## **Bayside Planning Panel**

Item No	6.5
Application Type	Section 96 AA Application – Modification to semi-detached dwellings
Application Number	DA-2016/74/02
Lodgement Date	11 July 2017
Property	9 Picton Street, Mascot Lot 27 Section 5 DP 937
Owner	Darren Finlayson
Applicant	Andrew Tzannes & Peter Smith
Proposal	Section 96 AA Application to modify Development Consent No. 2016/74, to increase the floor area, add one (1) bedroom to each dwelling and to install roof mounted solar panels to each dwelling.
No. of Submissions	Nil
Cost of Development	N/A
Report by	Matthew Hardwick- Development Assessment Planner

## Planning Assessment Report

Figure 2: Addition of solar panels

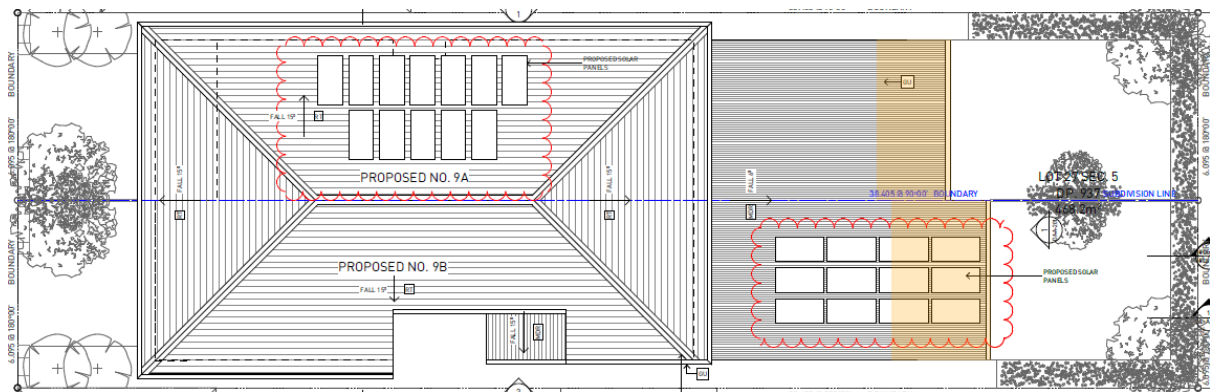
- The proposed modification includes the addition of solar panels to the northern upper floor rooftop of 9A Picton Street, and to the north-eastern ground floor rooftop of 9B Picton Street.

The panels on 9B are aligned to take full advantage of the morning sun, and midday sun. 9A is aligned to take advantage of the midday sun and afternoon sun. As the proposed modification for the solar panels will have no negative impacts on adjoining neighbours, the proposed modification is acceptable.
